Planning Board, ZBA
Loker Hearing 3/2/2021
3/9/2021

Willow Brook Condominium Associations

Loker Conservation
and Recreation Area

Conservation Commission Loker Hearing 3/3/2021

17 Ft wide access road

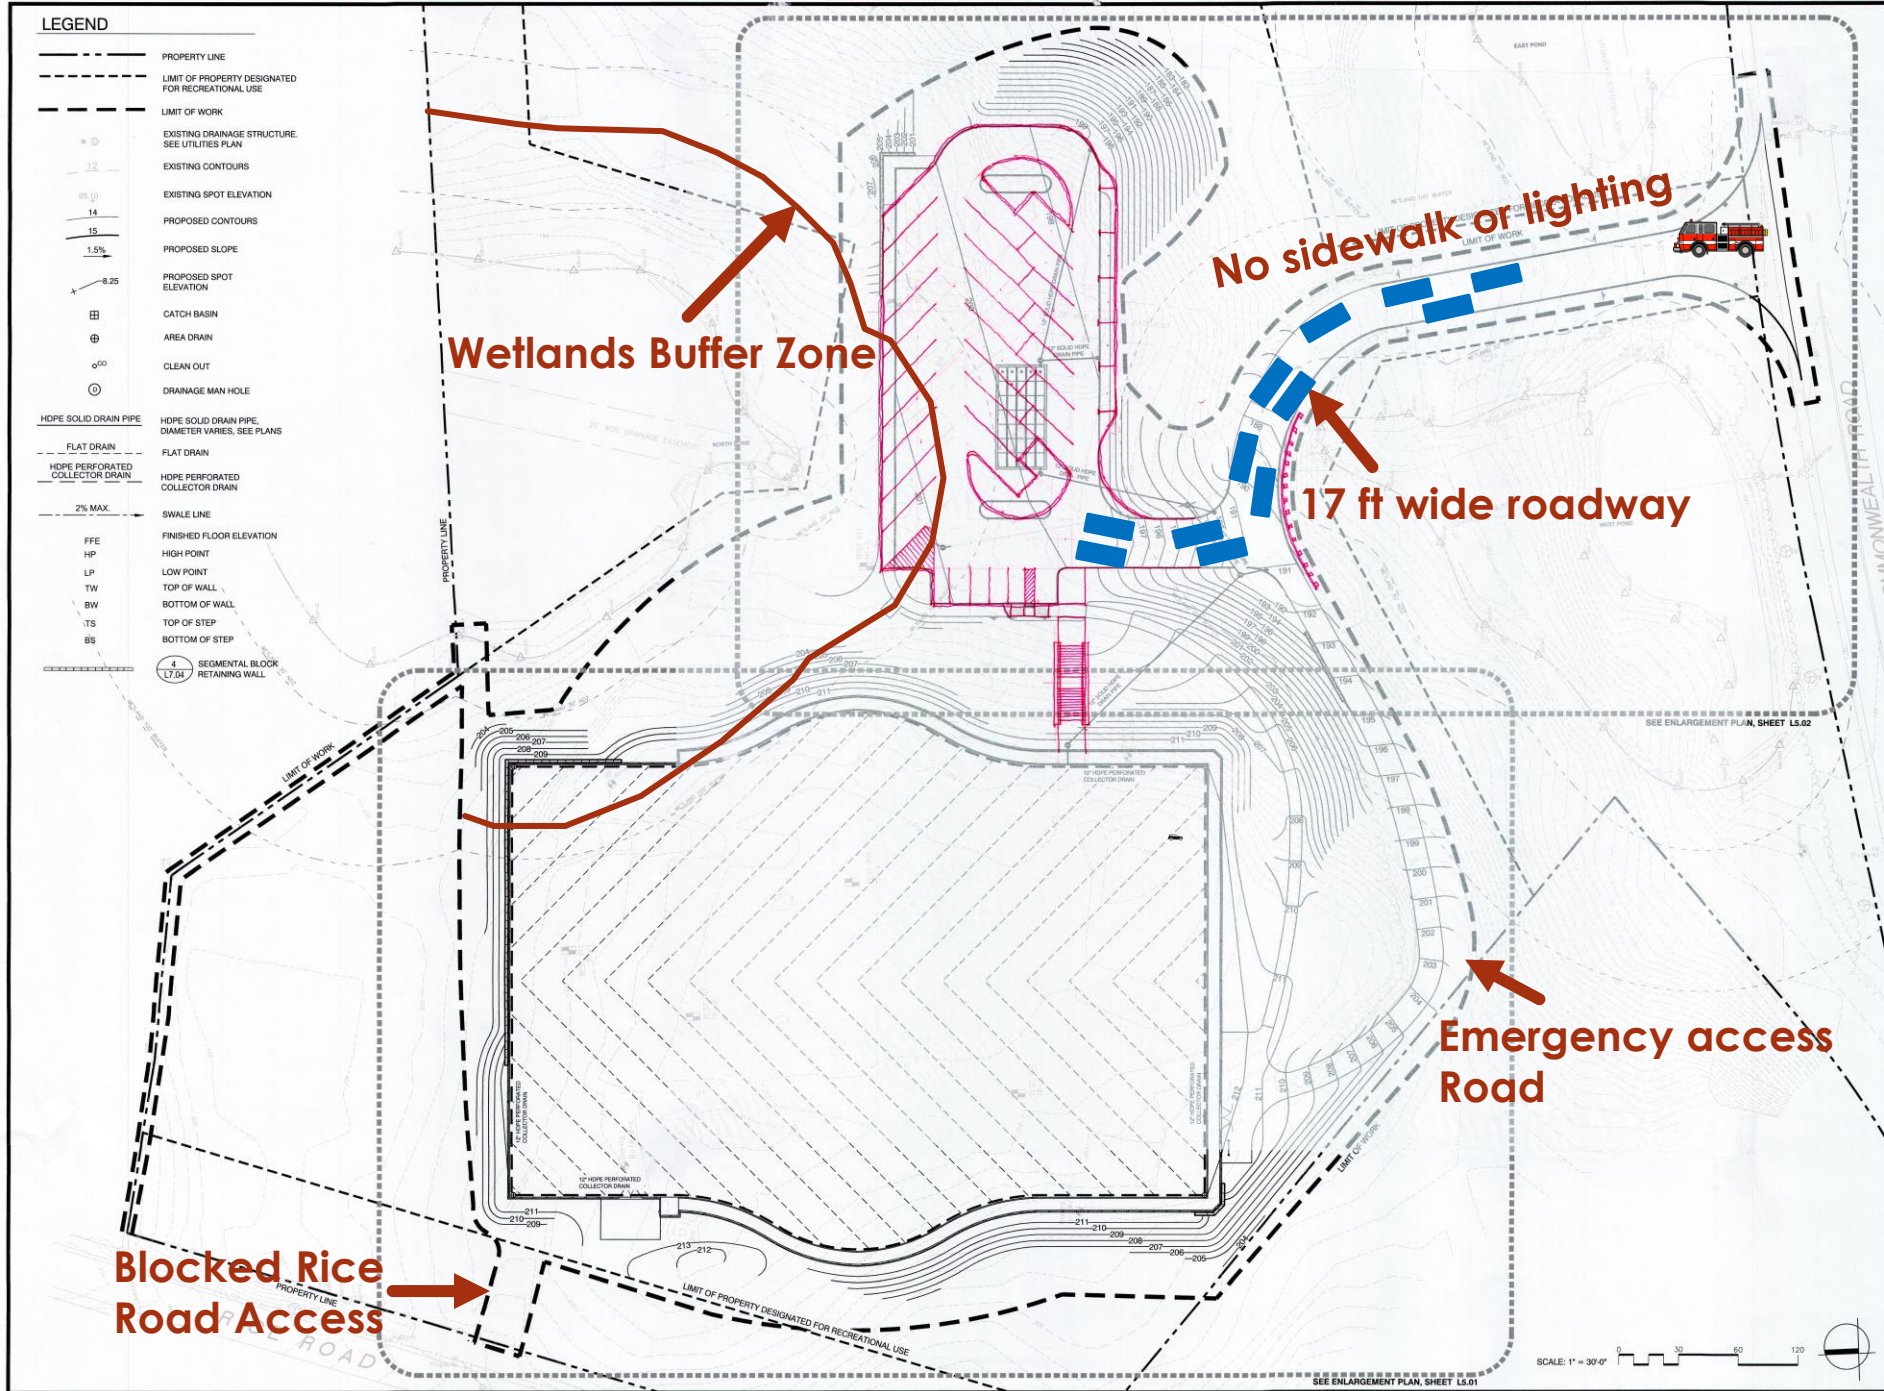
- Driveway is barely wide enough for two cars
- Sharp turn with steep slope
- No sidewalk Pedestrians compete with cars
- No lighting at night
- Emergency vehicles use the same access road
- Cars can't move to the side for emergency vehicles

L5.00

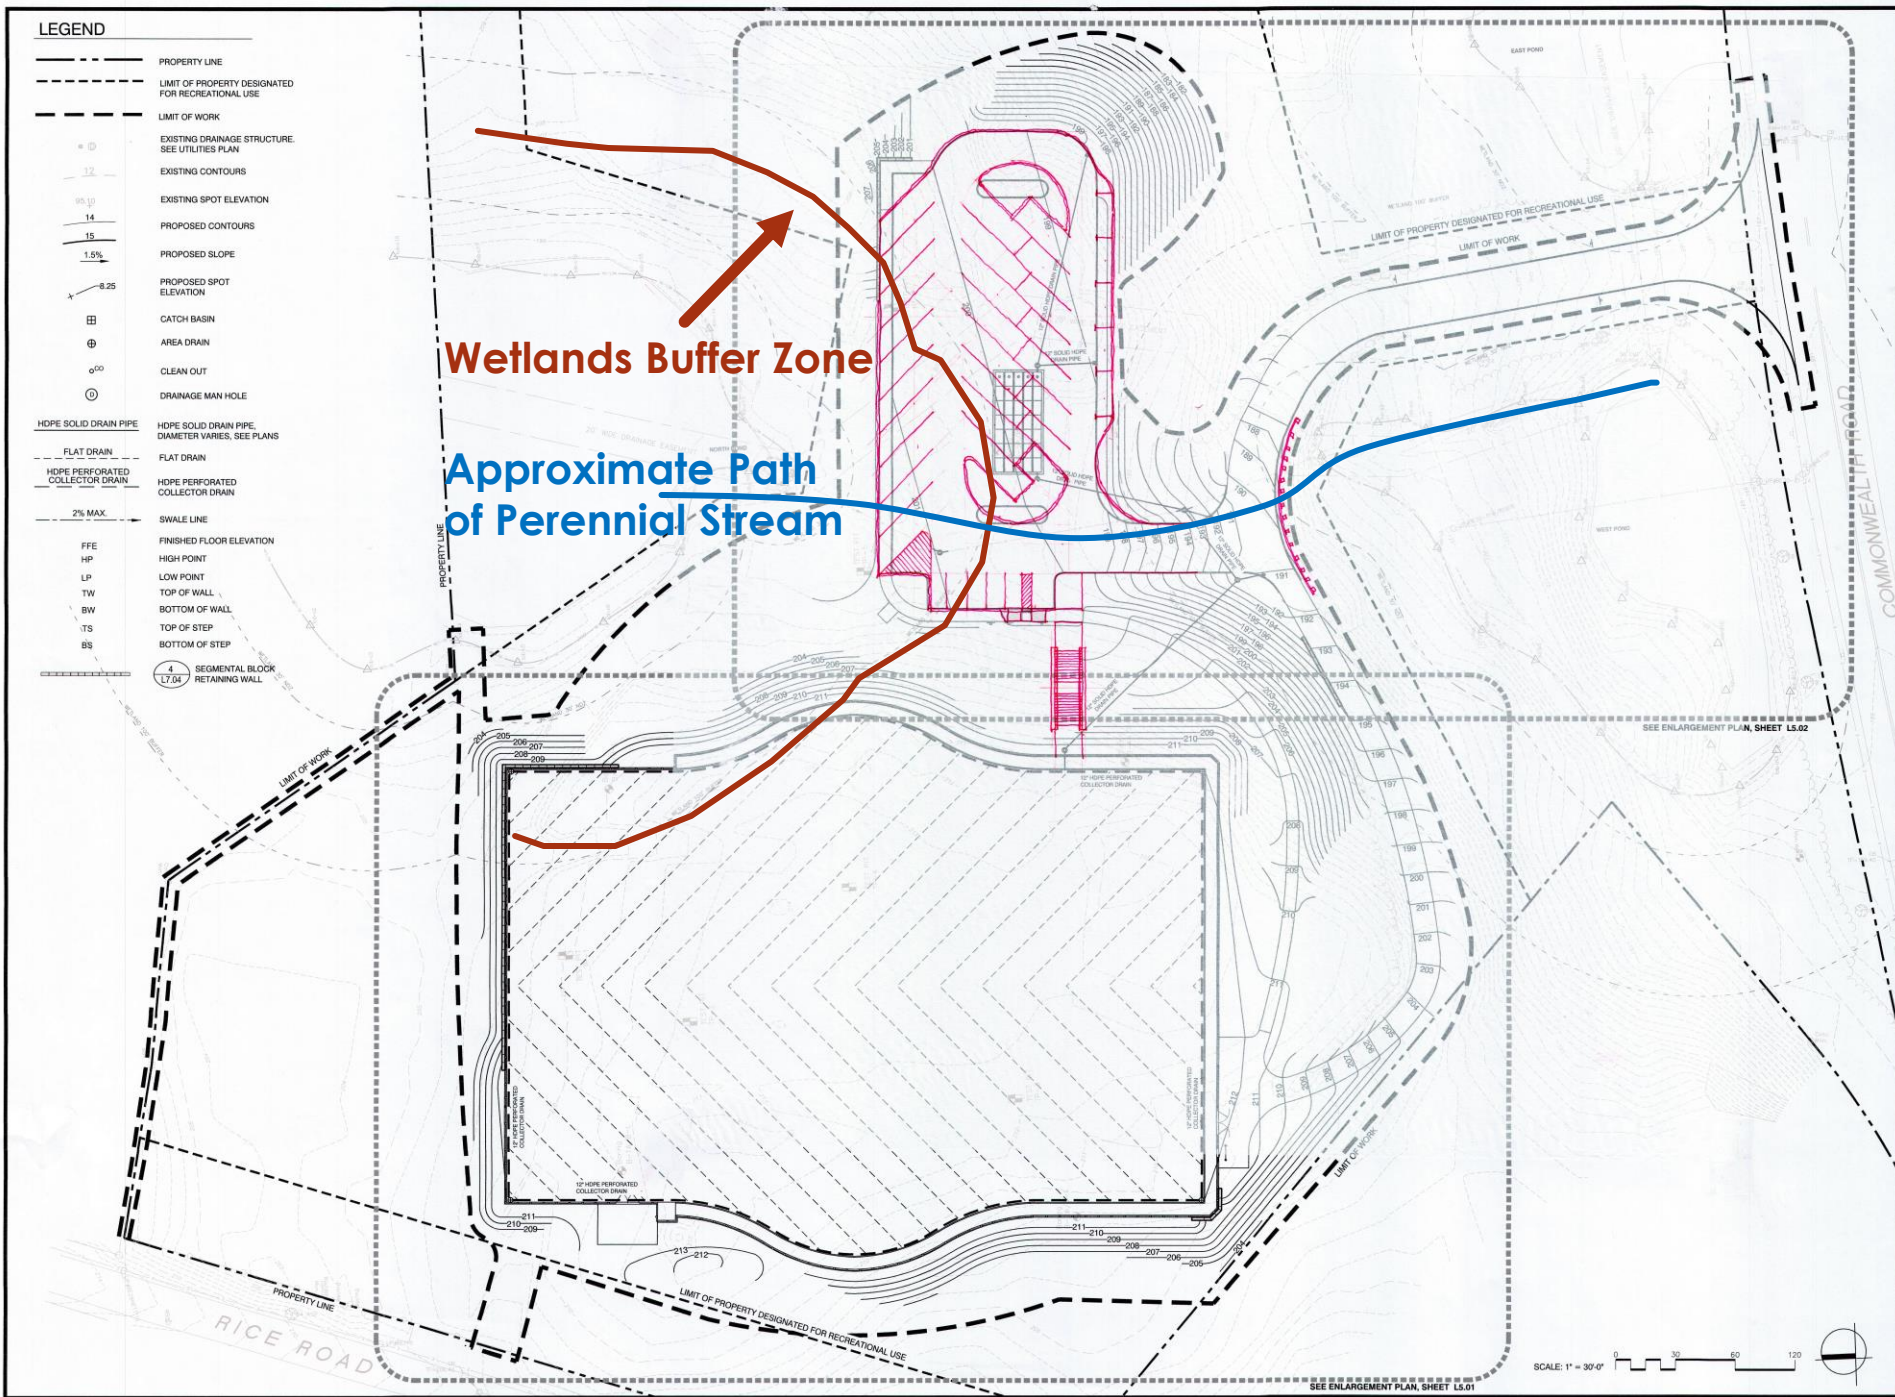
- ▶ **BSC Letter dated 8/31/2018 Section II Technical Items subsection a.** “ The proposed design of the infiltration system in this area will have a surface grade of approximately elevation 200, with the bottom of stone within these infiltration chambers at elevation 193.5 Per the MassDEP Stormwater Regulations, the minimum distance from the anticipated groundwater elevation to the bottom of the infiltration system is 2.0'. Based on the current available soils information, **the proposed design does not meet the DEP groundwater separation criteria.**”

- 
- ▶ **BSC response 9/26/2018** “BSC respectfully disagrees” “If the test pi(-s) find groundwater or bedrock less than 2’ below the proposed infiltration system, the system will need to be redesigned, resulting in a delay in construction as the redesign will need to be reviewed by the Commission. This redesign would likely increase overall project cost, **BSC has seen conditions like the one suggested by W&S used on other projects where adequate soils information has been previously obtained , but not within the exact area of the infiltration system.**”
 - ▶ *You are taking a severe cost and schedule risk if you just assume the will be 2’ of soil where you plan to put the storm water diffusion chambers”*

- ▶ **DEP 24 School Street appeal denial 8/16/2018 Page 2 last paragraph**
 - ▶ “in accordance with the MA Stormwater Handbook (Volume 2, Chapter 2), two (2) feet of separation is required between the seasonal high groundwater and the bottom of the infiltration system. In addition, at least six(6) of crushed, washed stone layer is required between the infiltrative surface and the o bottom of the galleys”

- ▶ **While the requirement is unproven the design might still work for Loker except the DEP 24 School Street denial also states**
 - ▶ “ The proposed subsurface infiltration system will be located under the driveway” MassDEP is also concerned about the impact of dead and live loads on the galleys and they surface they sit upon.” “Live loads such as the weight of a loaded moving truck are usually variable and have the potential to church galleys or to push them into the subsurface soils. Especial as no crushed stone layer is proposed”

- ▶ **The placement of the stormwater diffusion chambers under the Loker parking will also require a layer of crushed stone to prevent damage for constant car traffic.**

- ▶ The depth of the gravel, the height of the chambers, and the 2 feet of soil below the chambers will require that there will be approximately 10 feet space before hitting ledge below the parking lot.

- ▶ **All of the test holes dug anywhere on the hit ledge between 2 and 4 feet below the surface**
